STAFF REPORT & FINDINGS OF FACT
FLORENCE COMMUNITY DEVELOPMENT DEPARTMENT
Exhibit "A"

Date of Report: October 29, 2021 **Planner:** Roxanne Johnston
Application: AR 21 11 DR 02

Proposal: Administrative Design Review Land Use Application for the development of Oak Manor Apartments. This proposal consists of four 3-story buildings altogether containing 24-units for affordable workforce housing with outdoor amenities to be located on 1.24 acres at Assessor's Map 18-12-14-33, Tax Lot 01302, approximately 360 ft north of the NE intersection of Oak St. and 38th Loop. This property is zoned Highway District.

Exhibit E Excerpt

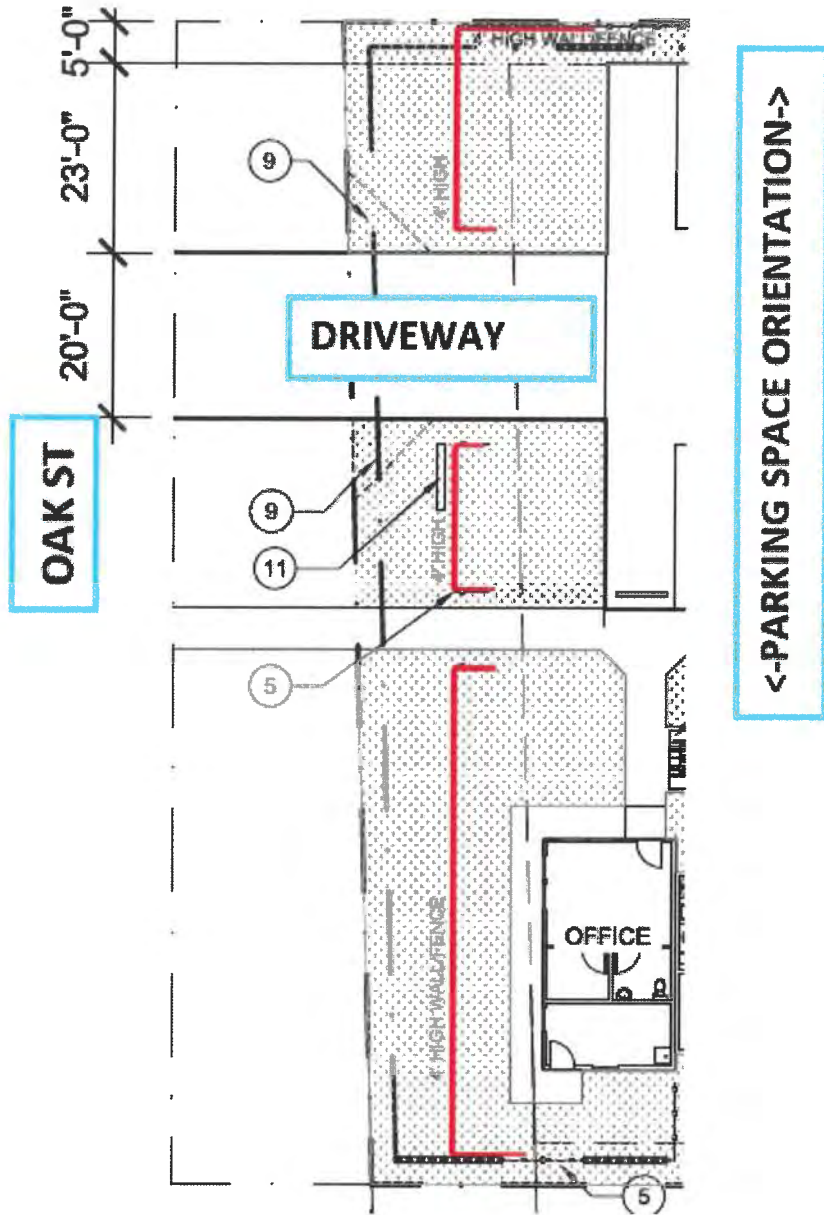
Parking spaces are situated whereby headlights would be directed either to the north or south of the property. Sections of 4’ fencing (shown in red, below) are planned to be located interior to the west property line, providing additional shielding towards Oak St. and residents on the west side of Oak St. as evidenced on the excerpt of Exhibit E, below:

The 4' fencing will also be constructed along the north property line to a point where it reaches a 6' fence located on the NW side of building D. More 6' fencing is planned intermittently along the east and south property lines providing privacy to first story residents, respectively. Where headlights would shine southward between buildings, the fencing would serve as a buffer. Additionally, a raised linear landscaping area along the north fence line is proposed to contain a hedge of Escallonia Dwarf shrubs. A mix of deciduous and evergreen trees are planned to flank the south property line.

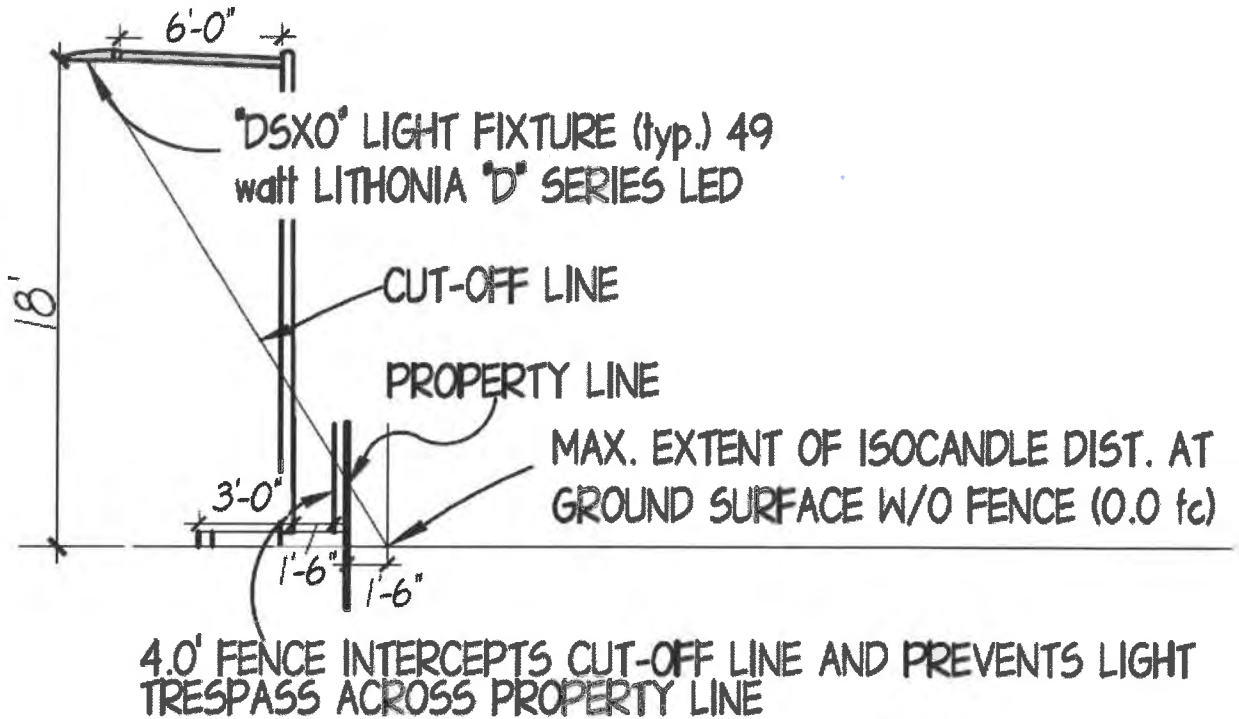
The Lighting Plan (Exhibit I) and product specifications demonstrate all exterior lighting fixtures are designed to be full cut-off so that direct light emissions are directed downward and would not shed onto adjacent properties or skyward. Criterion met.

The Lighting Plan demonstrates that there are areas in the most northern area of the parking area that do not meet the minimum requirement of 2 foot-candles. Additionally, bicycle area lighting nearest the office measures 16 foot candles whereas another measures only one. To meet requirements of FCC 10-37 3, the applicant shall either amend the Lighting Plan to reflect compliance or request an exception to be decided upon by the Planning Commission. **[Condition 28]**
